RE: 230 Martin Road, Badgerys Creek - Industrial Development (SSD-65529236)

LCC Comments RE: 230 Martin Road, Badgerys Creek

Figure 1. Road Infrastructure in Western Sydney Aerotropolis

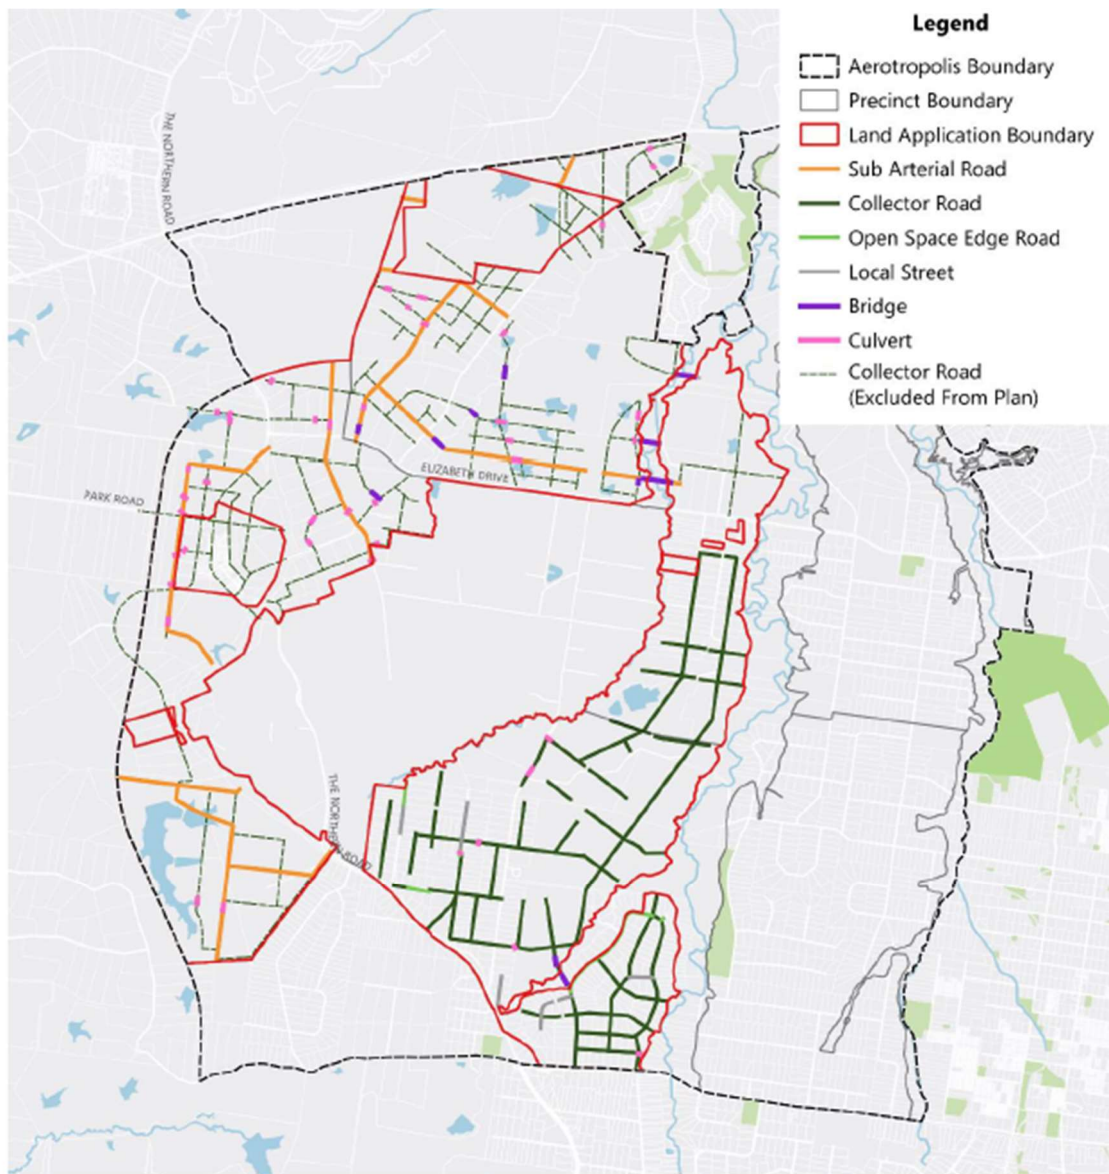
9. The subject site is affected by the proposed collector road as per 7.12 Council's Aerotropolis Precinct Contribution Plan (Map 1). Confirmation is required for design requirements of this proposed collector road and associated the road reserve.

10. The Eastern ring road is planned to be a future principal arterial road. Part of the Martin Road, north to the subject site will be widened and form part of the Eastern ring road. Consultation is required with Transport for NSW for the design of the Eastern Ring Road and its connection to the remaining section of Martin Road which is fronting to the subject site. Both interim and ultimate access arrangements to the subject site are required to be identified and included in the TIA report.

Figure 2: Typical Collector Road

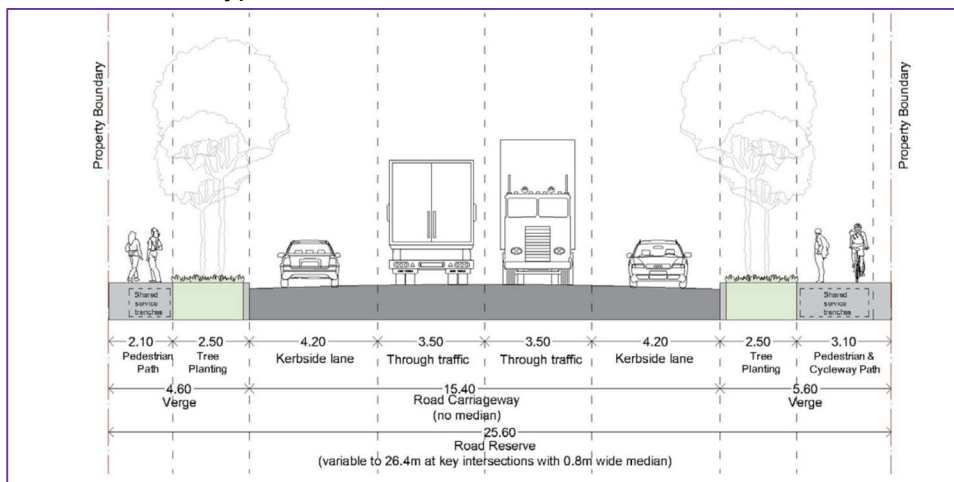
The development has not proposed any public domain design or tree planting within the streetscape. The design of the local road network must follow the Western Sydney Aerotropolis Development Control Plan, as below:

- Martin Rd - Typical Collector Road

Figure 3: Typical Open Space Edge Road

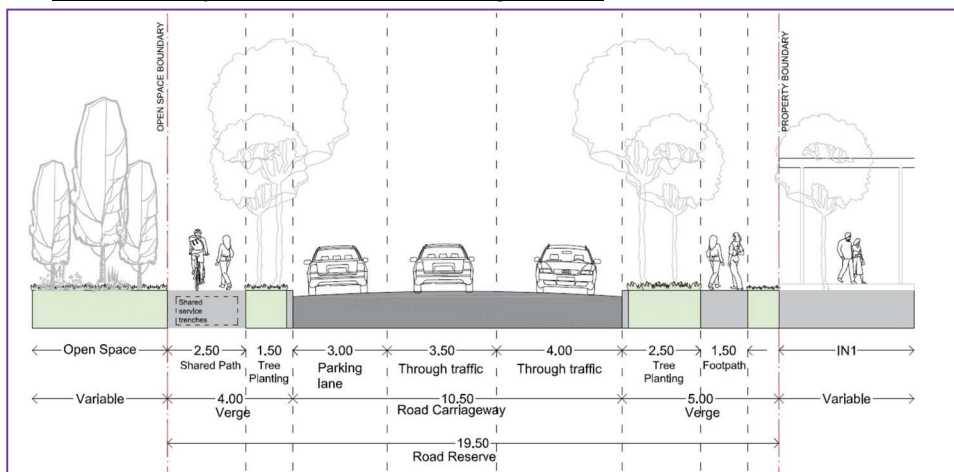
- Park Rd - Typical Open Space Edge Road
